Permit Number: 030120

This is to certify that Fitch, Ronald & Sandra/Own  
has permission to Build 6,529 sq. Ft. Home on <sup>with</sup> existing shed  
AT 92 West Shore Dr - Get O Island 083E A005001

**Dept:** Building      **Status:** Approved with Conditions      **Reviewer:** Tammy Munson      **Approval Date:** 03/25/2003**Note:** rec'd new plans - 03/25/2003 - discussed the followinf conditions w/ Scott Teas.      **Ok to Issue:**

FITCH RESIDENCE  
GREAT DIAMOND ISLAND, MAINE

1 FIRST FLOOR PLAN  
A-1 3/16" = 1'-0"

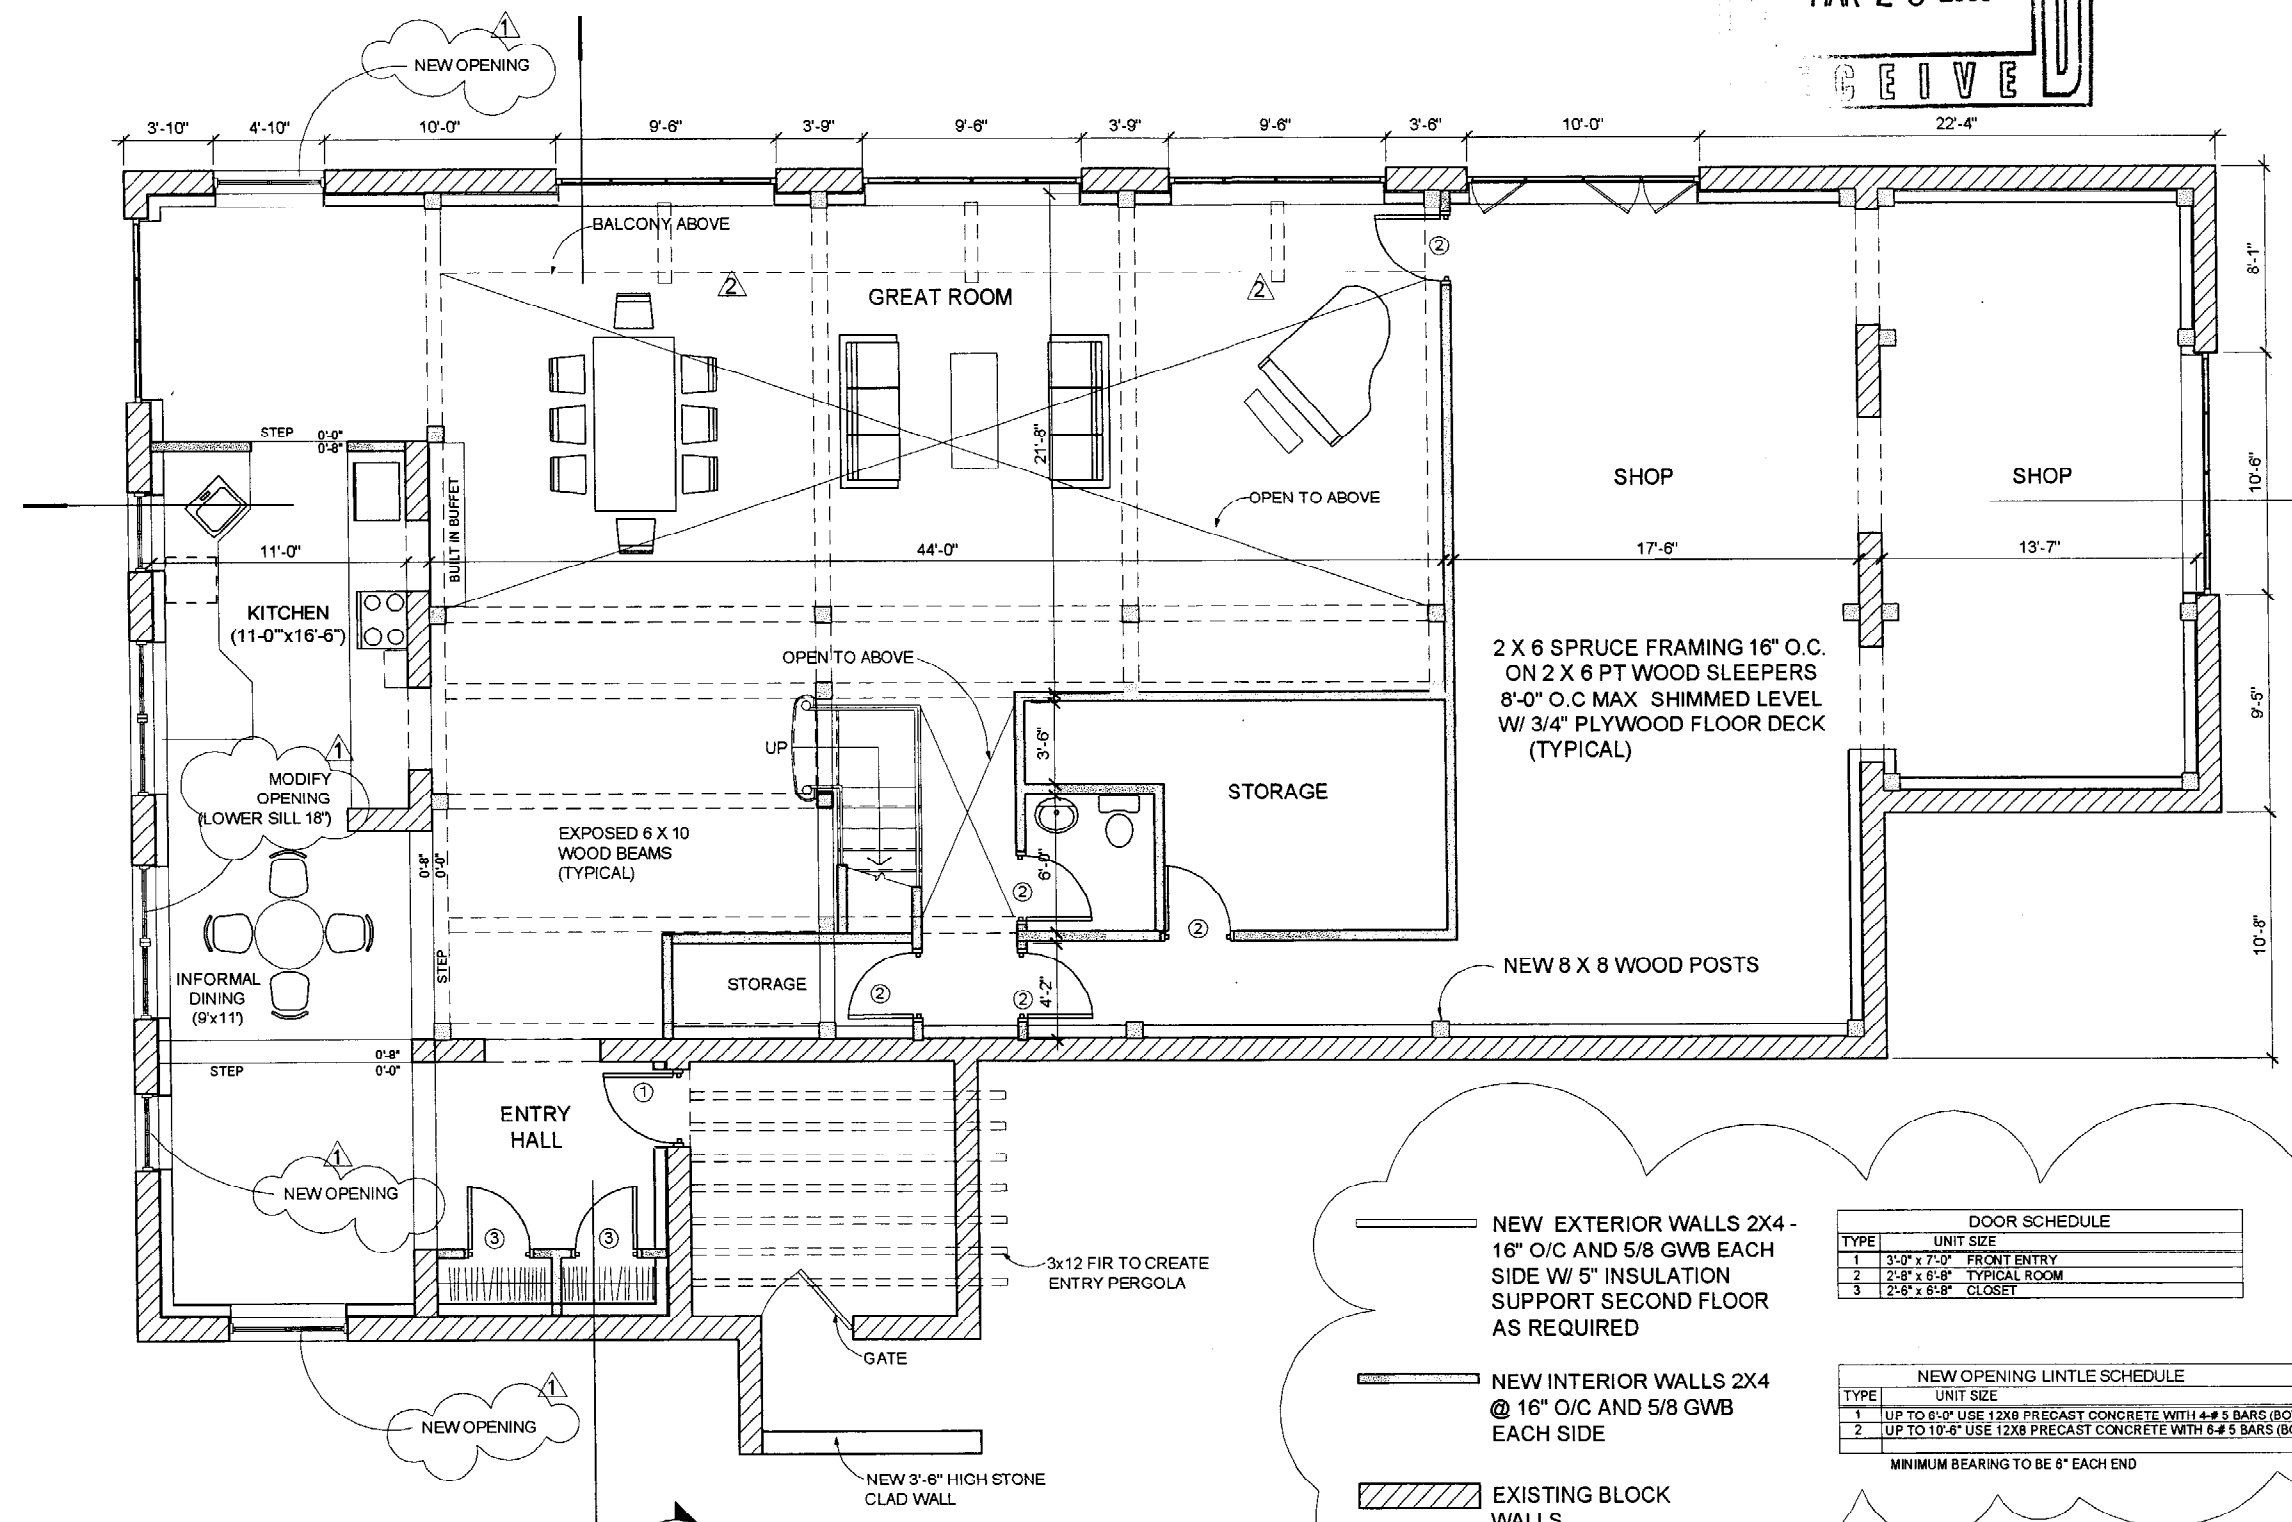
- 1) The lowest point of opening on egress windows must be 44" or less above the finished walking surface.
- 2) Guardrails MUST be 36" minimum measured from the leading edge of the tread protecting all stairways.

3/21/03-tm: Spoke w/ Scott - need to stamp plans and address catwalk width(3'), guard heights and egress windows.

3/25/03-tm: rec'd new plans - ok to issue.
